Details pursuant to condition 3 (external materials) and 4 (external lighting) – Tunstall Primary School, Tunstall Road, Tunstall (SW/14/153)

A report by Head of Planning Applications Group to Planning Applications Committee on 11 February 2015.

Application submitted by Kent County Council Property and Infrastructure Support for further details pursuant to condition 3 – details of external materials, and condition 4 – details of external lighting at proposed Tunstall Primary School, Tunstall Road, Tunstall. (Ref: SW/14/153/R3 & R4).

Revised lighting scheme submitted as part of the discharge of external lighting condition.

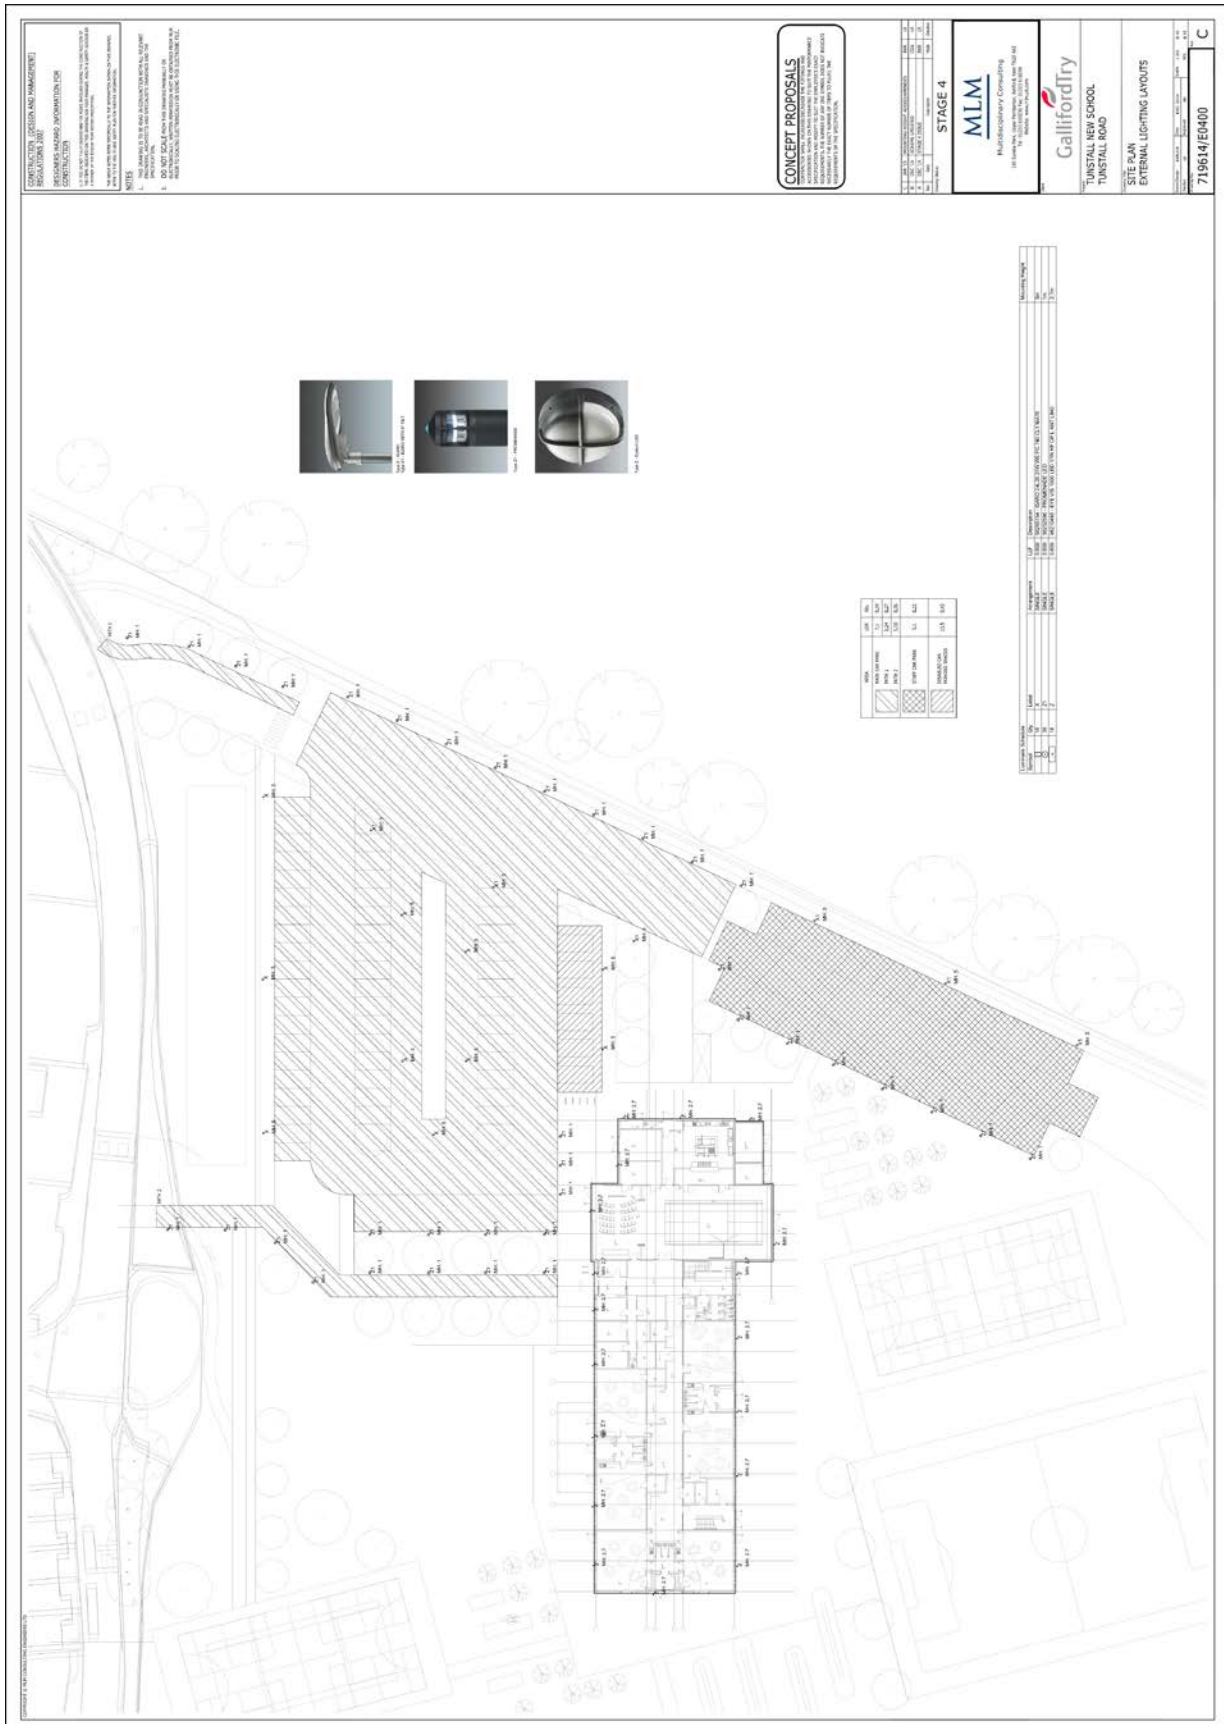
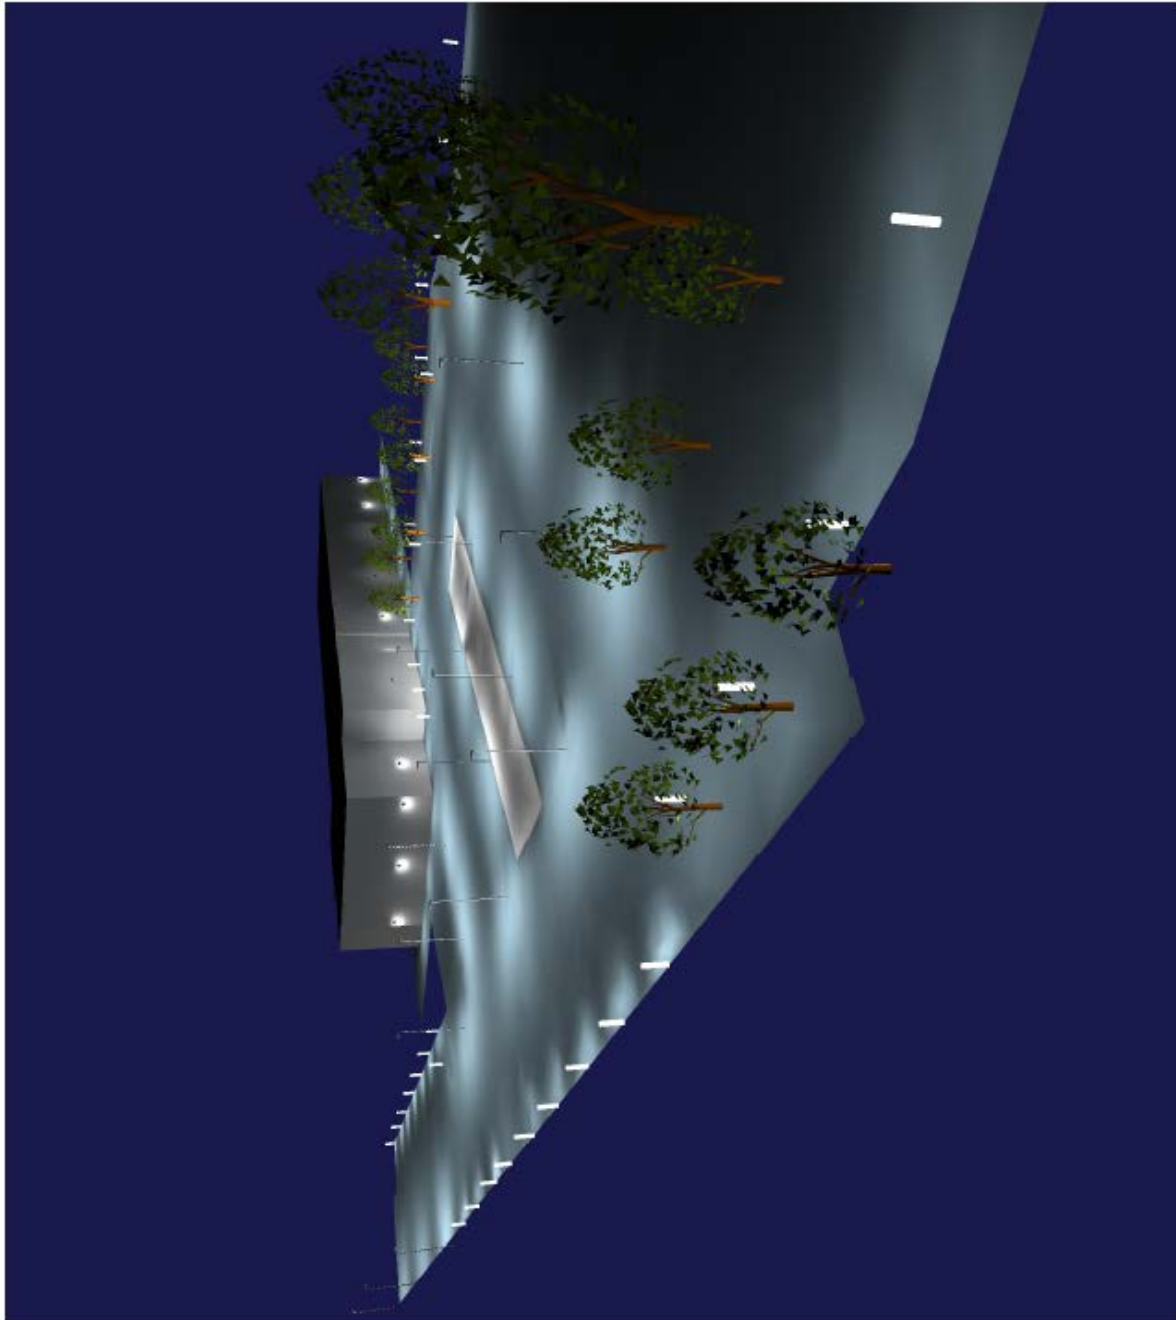
10. Following concerns raised by Tunstall Parish Council and 2 local residents over the number of the 5 metre (16.4ft) high column mounted luminaires, the proposed external lighting scheme has been amended, substituting some column lighting for lower level bollard lighting. Drawings showing both the original and amended proposals are attached. The amendments are as follows:

"Members would ask that all lighting 'A' (5m high column mounted luminaires) is substituted for lighting 'B' (1.15m high bollard luminaires), this precedent has been set by with the Village Hall (there are no columns just pillar lighting) and most of the village has no street lighting, apart from that in lower part of Tunstall Road, County installed because of the traffic calming. If this is not possible then Members would prefer 3m columns for 'A' (5m high column mounted luminaires) to try and reduce light pollution to nearby properties. Members would also like clarification as to what times the lighting will be 'on' and what limits will be put on this."

At the Contractors, KCC etc, meeting it was also advised that there will be 16 lighting columns, an increase of 100%. Again despite being advised of 8 at the Parish Council meeting this too has changed. Tunstall does not have any street lighting (apart from that imposed on us due to the traffic calming in the lower part of Tunstall Road). If you visit the village hall it only has pillar lighting and this is only switched on for functions. We asked that the columns be reduced in number; that most full length columns be reduced in height and that columns be substituted with the ground level pillar lighting; to avoid pollution and nuisance to nearby neighbours and the surrounding rural area.

- Primary concern is the number of and height of the lights listed as A (5m (16.4ft) high column mounted luminaires) on the plans;
- Despite suggestions to the contrary the height and quantity will give light overspill to residents throughout Tunstall;
- The 5m high columns should be replaced by those identified as B (1.15m (3.8ft) high bollard luminaires) on the plan, giving low level lighting which will not be as intrusive to residents;
- The amount and height of these lights will have a large impact on the local residents;
- They will be a complete source of light pollution to Tunstall Road, Ruins Barn Road and Cranbrook Drive.

- 16no 5m (16.4ft) high column mounted luminaires are proposed, as opposed to the previously approved 26no;
- 36no 1.15m (3.8ft) high bollard luminaires are proposed as opposed to the previously approved 10no;
- 18no wall mounted luminaries are proposed to be located on the building, as opposed to the previously approved 15no.

25. The lighting scheme has therefore been amended, in response to the Parish Council's and local residents concerns, to now include 16no 5m (16.4ft) high column mounted luminaires (as opposed to the previously approved 26no); 36no 1.15m (3.8ft) high bollard luminaires (as opposed to the previously approved 10no), and 18no wall mounted luminaires to be located on the building (as opposed to the previously approved 15no). At the location of the proposed vehicular entrance to the school site, there were two 5m (16.4ft) high column mounted luminaires proposed but these have now been replaced by four of the 1.15m (3.8ft) high bollard luminaires. Further along this same boundary, a further four 5m (16.4ft) high column luminaires have been replaced with nine 1.15m (3.8ft) high bollard luminaires. Therefore the 5m (16.4ft) high column luminaires are now reduced in number and concentrated around the middle of the parents'/visitors' car park and along the eastern boundary of the staff car parking area. To make up for the loss of lighting that the 5m (16.4ft) high columns would provide has by necessity resulted in more 1.15m (3.8ft) high bollard lighting being provided than was shown on the original planning application. Unfortunately the 5m (16.4ft) high columns could not be replaced by 3m (9.8ft) high columns, as to get the same light coverage would have resulted in more columns, rather than less, being installed on this site in order to achieve the necessary level of illumination. The lighting scheme has also taken glare and overspill of lighting into account and this can be seen in the detailed lighting analysis that has been provided and which is included within this report.

26. As this is a school site, then there is a certain amount of lighting that is required as the School has a duty of care to its parents, staff and visitors to the site. It is not good practice to use bollard lighting in car parks, as any parked vehicle blocks out the light to the main area and this is why all bollard lighting is not considered acceptable for this site. The external lighting scheme for this site has been designed in accordance with BS (British Standard) 5489:2003, which gives standards for the lighting of outdoor car parks. In this case, the level of lighting should have a lighting level of 20lux, which is the requirement for a school car park as it is classified as a Heavy Traffic car park. However most of the vehicular traffic at a school site is during daylight hours and hence this is when the lighting will not be on. The majority of school staff will be arriving and leaving the car park during the times when the external lighting will be switched on and so in this instance the usage can be classified as Medium Traffic car park. For Medium Traffic car parks, the level of lighting can be reduced to 10lux. Therefore the external lighting scheme has been designed based on a 10lux lighting level and will result in a lower level of lighting than originally planned.
